Re: Rapiscan AIT System Radiation Survey Reporting

Rapiscan Secure 1000

**R-0646-1 Addendum
(Documentation Errors)**

Product Name	Secure 1000SP (Single Pose)
Serial Number	S51007001
Radiation Emission Measurement	Radiation Survey Dated: 06/16/2010
RSO Initials

2. Radiation Leakage Measurement: Survey Table. 2

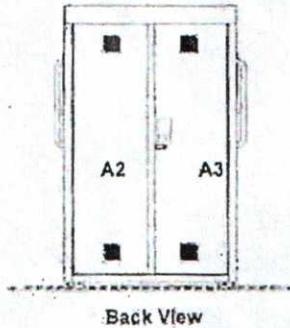
1. TABLE 2: Incorrect presentation of data in Column 3 for Measured Exposure. Indicated value is .1 uRem. The correct value should be 1 uRem.
2. TABLE 2: Incorrect presentation of data in Column 6 for Dose Equivalent. Indicated value is .18 uRem. The correct value should be 1.8 uRem.

The service technician should attend refresher training.

The corrected data indicates this system was operating within expected parameters. No re-survey is required for this system.
